FF-L-2740
INT. AMENDMENT-1
February 9, 1994

INTERIM AMENDMENT

FEDERAL SPECIFICATION

LOCKS, COMBINATION

FIGURE 1
Schematic arrangement of lock case holes

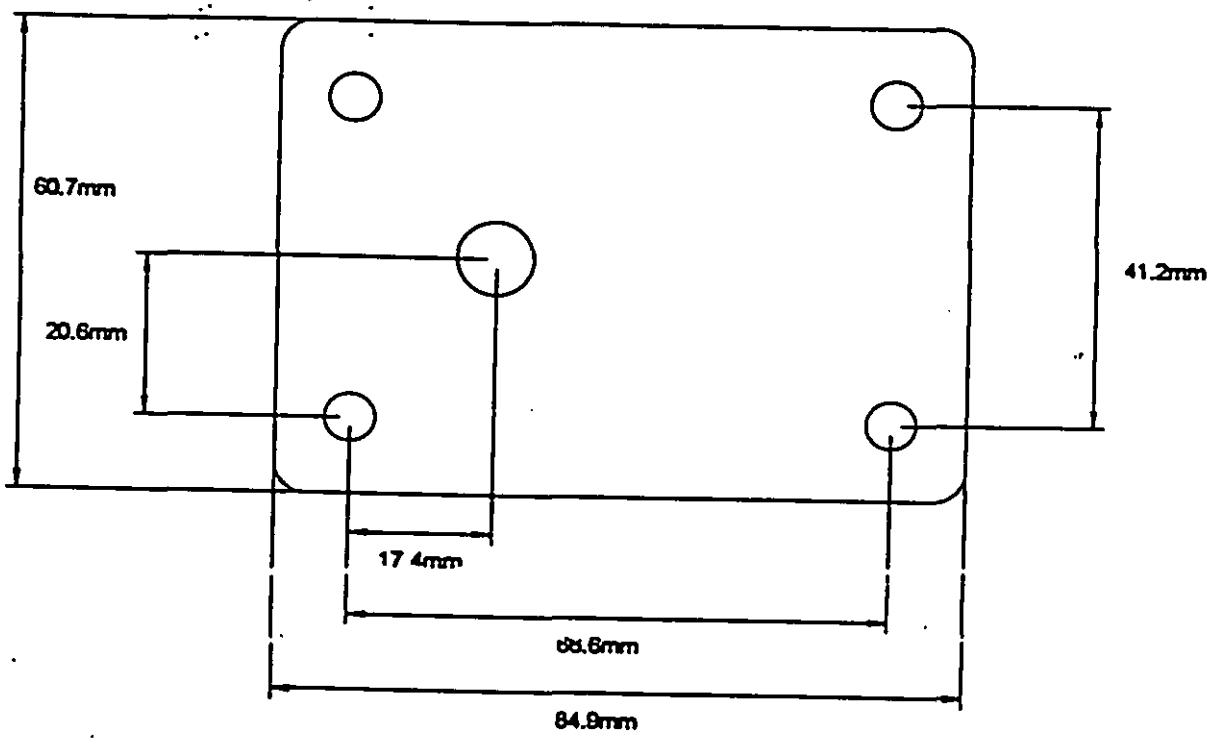
Delete Figure 1 and substitute the attached Figure 1.
